**To: Port Stephens Council General Manager**

**Re: BESS 1154 Clarence Town Rd, Seaham – 5 DA’s numbered:**

**16 - 2023 - 382 – 1, 16 - 2023 - 383 – 1, 16 - 2023 - 384 – 1, 16 - 2023 - 385 – 1, and 16 - 2023 - 386 – 1**

**Figure 3: Biodiversity Values Mapping**  
*Source: NSW ePlanning Portal accessed Feb 2023*

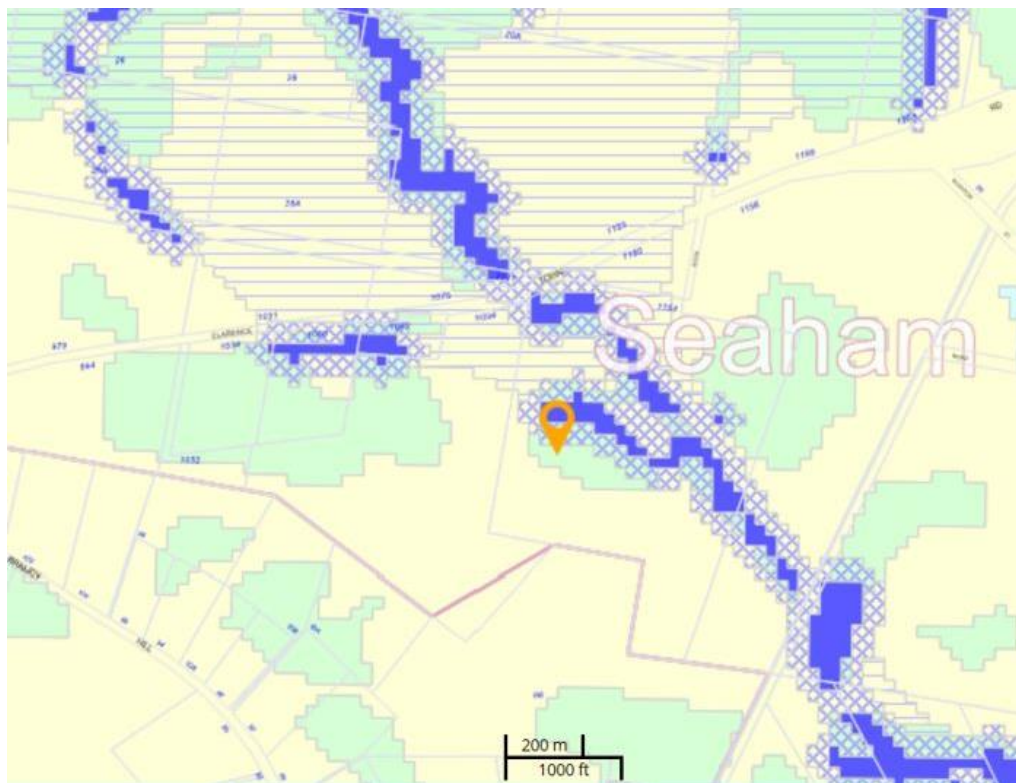
Some figures, for example Figure 3 of the SEE showing Biodiversity Values Mapping, only shows the location of a portion of the Preferred Koala Habitat. Compare the SEE figure to the cross-hatched sections of preferred habitat existing over marginal or cleared land area shown on CKPOM koala habitat mapping and it is clear that the SEE figure downplays an essential part of the wildlife corridor which traverses this property. A comparison is provided below which shows how even a small section of the CKPOM mapping provides a clearer picture of how important the wildlife corridor through this site is for connectivity.

Crosshatching from CKPOM mapping is not shown in the SEE Figure 3. The Wildthing EAR figure 8.2 [following] shows clearly that that the BESS is placed on habitat buffer land.

Figure 8.2 Revised Port Stephens CKPoM Koala Habitat Mapping within the study area

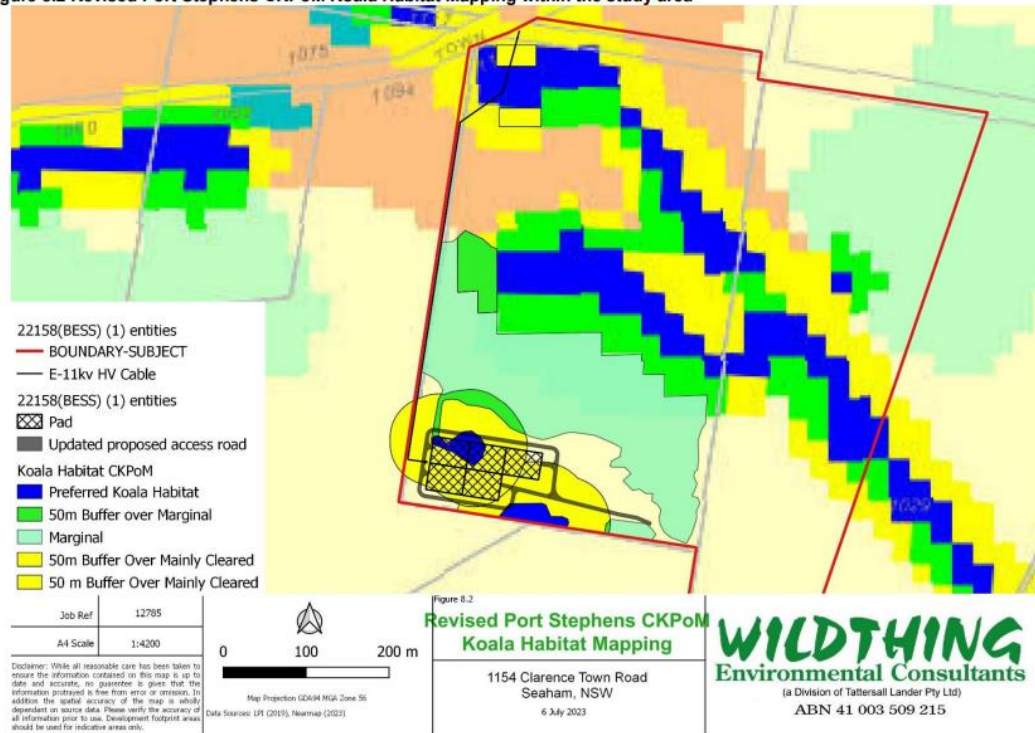
These maps clarify that the proposed development and planned underboring will affect more koala habitat than may be at first apparent.

**KKEPS submits that the full extent of the buffer habitat land identified in Fig 8.2 be considered, to calculate if the proposed development may exceed the threshold for the biodiversity offsets scheme.**

Figure 5.2 (EAR) surveyed tree locations.

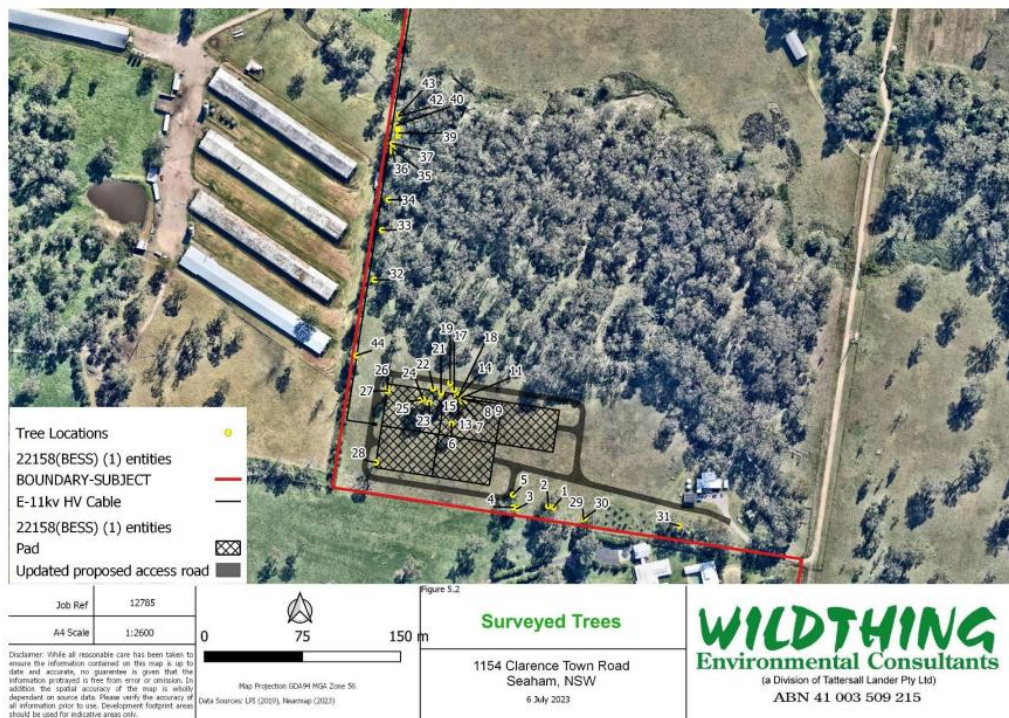
In section 5.2.2 (TREE SURVEY), Wildthing note that 33 trees out of a total of 44 native trees recorded within the impact area will or are likely to be removed. They also mention that there is scope to reposition the cable to reduce any impact on the structural root zone of some of the trees. Tree No. 39 may require removal, but Wildthing have recommended that it is retained as it contains hollows. Up to eight other hollowbearing trees may hollows require removal. The proposal will also require the removal of 15 specimens of *Eucalyptus tereticornis* (Forest Red Gum), a Koala Food Tree species under the Port Stephens CKPoM. An additional two specimens of *E. tereticornis* (Trees No. 5 and 44) may also require removal, however Wildthing believes there is scope to retain both and recommends that they are not removed. Details of each of the 44 trees including height, diameter at breast height (DBH), coordinates and fauna habitat attributes such as hollows are contained Appendix B. The location of the 44 trees are shown in Figure 5.2 [following].”

It is not clear if the Wildthing’s recommendations to avoid impacting native trees has been accepted, but the same information is not contained within the SEE, which raises doubt. Similarly, Wildthing notes many mitigation measures to be followed (pp. 53-54). These should be made conditions of approval if Council consents to these applications.

Figure 3.1 Biodiversity Values Map

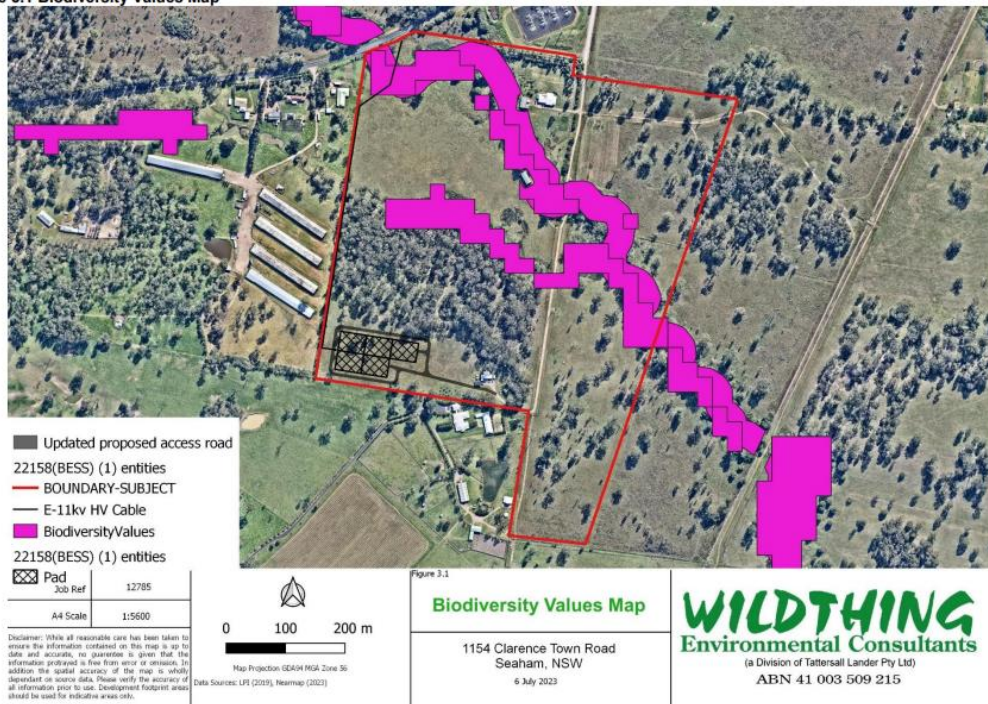
Wildthing state that “The NSW Biodiversity Values Map was consulted on the 18 May 2023 (see Figure 3.1 overleaf]. As of this date it was determined that there were areas of mapped ‘Biodiversity Values’ (BV) within the subject land.

While the underbore points for the proposed cable will be positioned outside of the BV mapping, **the proposal will underbore the proposed cable within the location of the mapped Biodiversity Values (BV)**. While only recognising the underbore points outside of the BV mapping area, the proposed development will not exceed the biodiversity offsets scheme threshold in regard to Section 7.2(b) of the BC Act. An extract of the Biodiversity Values Map has been provided in Figure 3.1.”

KKEPS does not agree with the Wildthing assumption that “Proposed underboring of the Preferred Koala habitat within the northern extent of the proposed cable installation will therefore not impact this habitat, with the underbore points located outside of the Preferred Koala Habitat. No areas of habitat are likely to become significantly fragmented or isolated from other areas of habitat as a result of the proposed action.” As there is no reference to any evidence of underboring being a successful method, we can’t agree that fragmentation nor isolation will not occur. KKEPS believes the underboring will affect the vitality of the trees by interfering with their root systems.

**Figure 5: Bushfire Mapping**

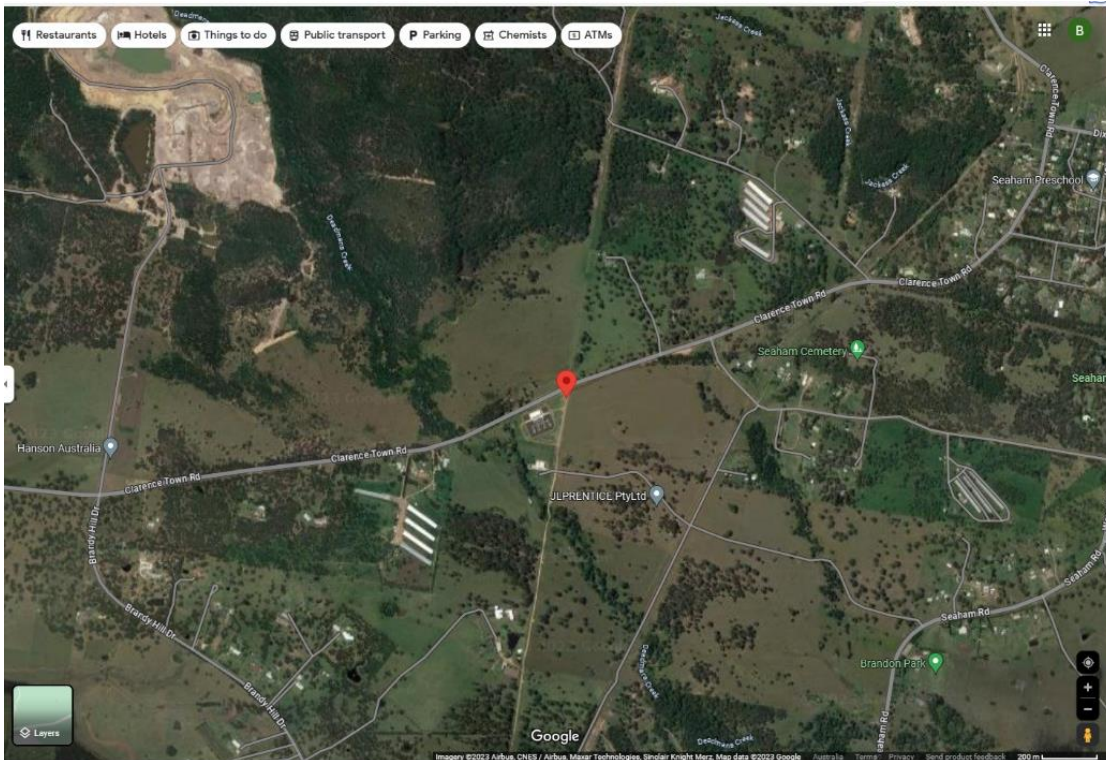
The proposed BESS development site is near the highest fire danger area as shown in Figure 5 [below], being adjacent to the best habitat on the Lot, as well as being near the neighbour's apparent chicken sheds.

Figure 1.2 Aerial Image of Subject Land

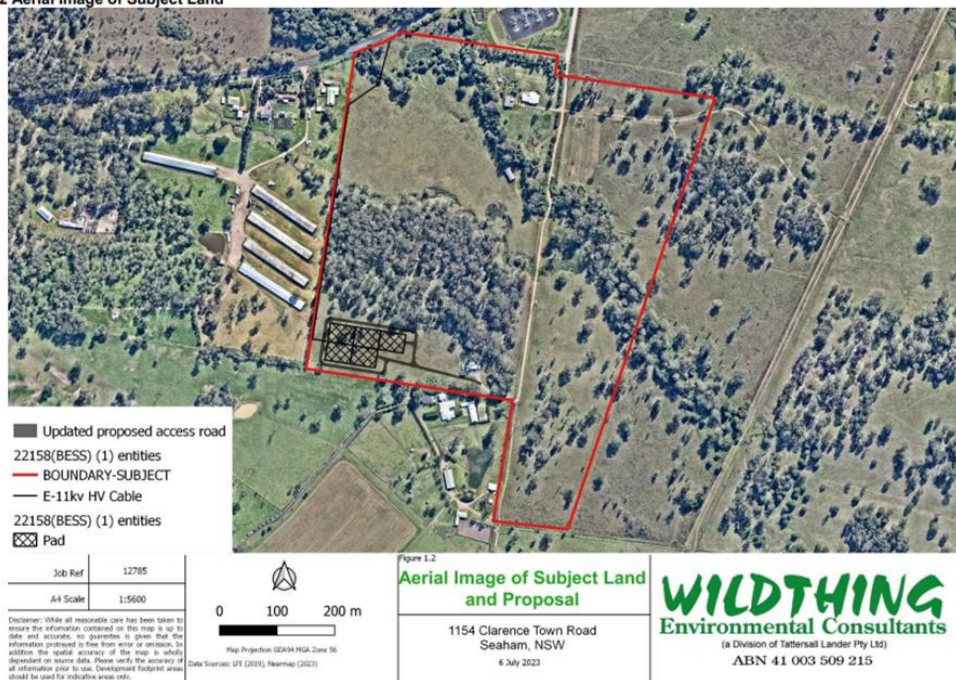
KKEPS is concerned that the location of the BESS near two homes, one on a neighbouring property, will provide a poor visual and noise impacts upon them.

The statement on p26 of the SEE that “There will be some additional noise during the installation period, however, this will be relatively minor and not considered to be offensive” may not be agreed with by the neighbours living at the southern end of the block.

See figure 1.2 following for an aerial imagine of the site showing the proximity of the BESS to neighbouring homes and existing farming infrastructure.

Although a perimeter screen planting of shrubs and trees is proposed to the east and south of the development, KKEPS submits this will take some years “to effectively screen the BESS from the surrounding developments.” The plants chosen are fairly fast growing, but short-lived.
